# Special Bulletin

# SP15-306

## KNEELING EXHAUST MUFFLER Prevost vehicles

Figure 1

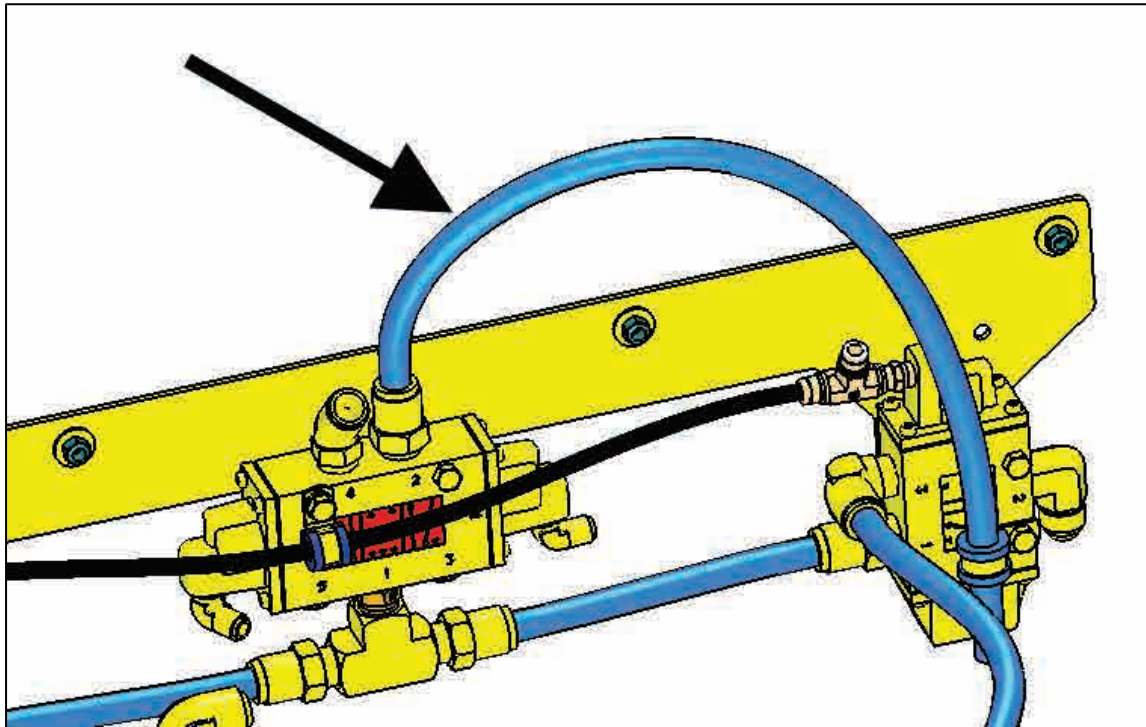
- 1) On the rear wall of the front wheel housing, center section, dismantle the existing kneeling valve exhaust tube and P-clamp.

Figure 2

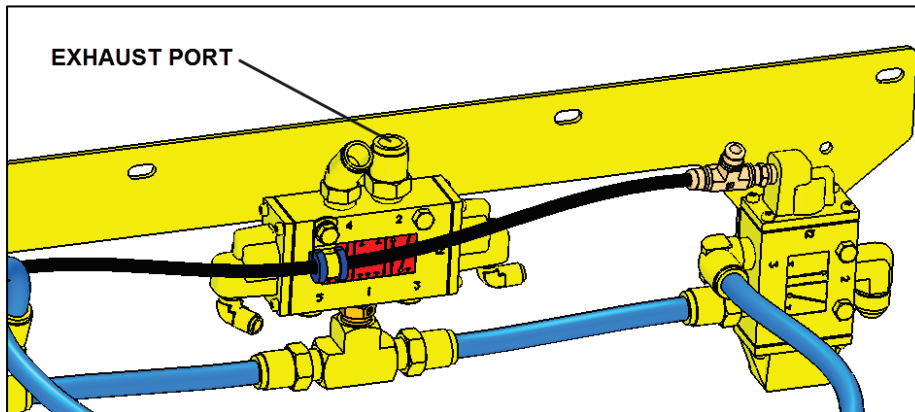
- 2) Connect a blue #503517 tube to kneeling valve exhaust port.

Figure 3: Road side view

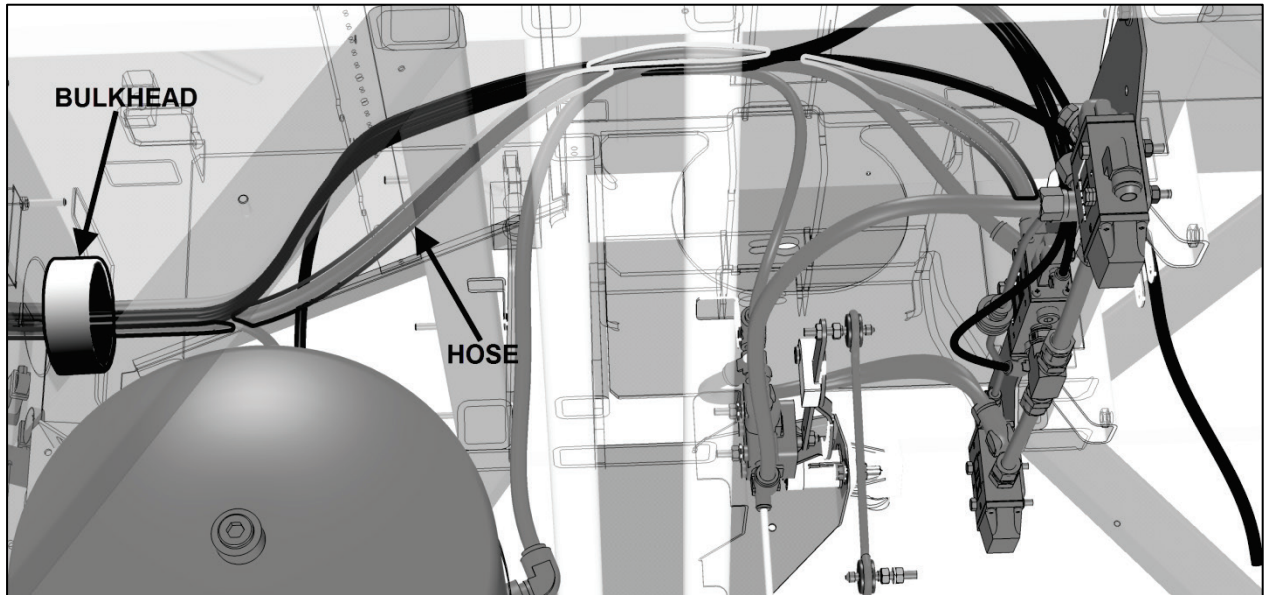
- 3) Route tube #503517 forward thru bulkhead tube in vehicle structure and to spare tire compartment.

Figure 4

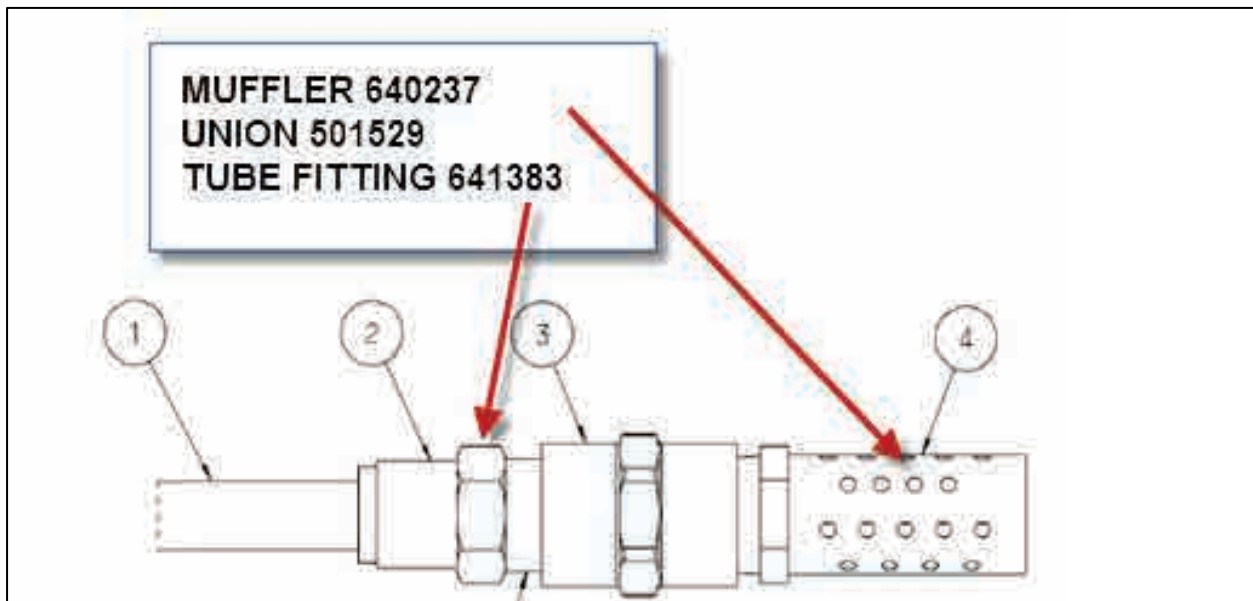
- 4) Assemble muffler and fittings according to Figure 4. Use Teflon sealant.

Figure 5

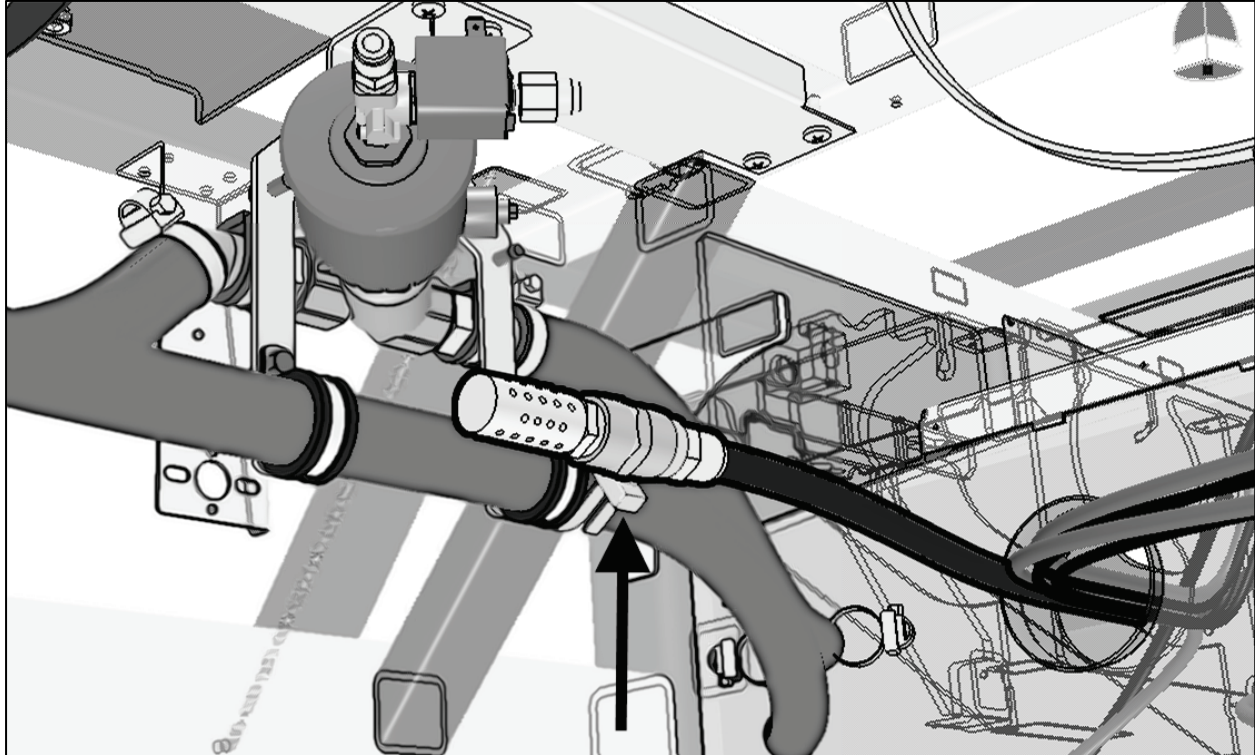
- 5) Attach tube to hot water valve hose with double head cable tie.(Fig. 5)
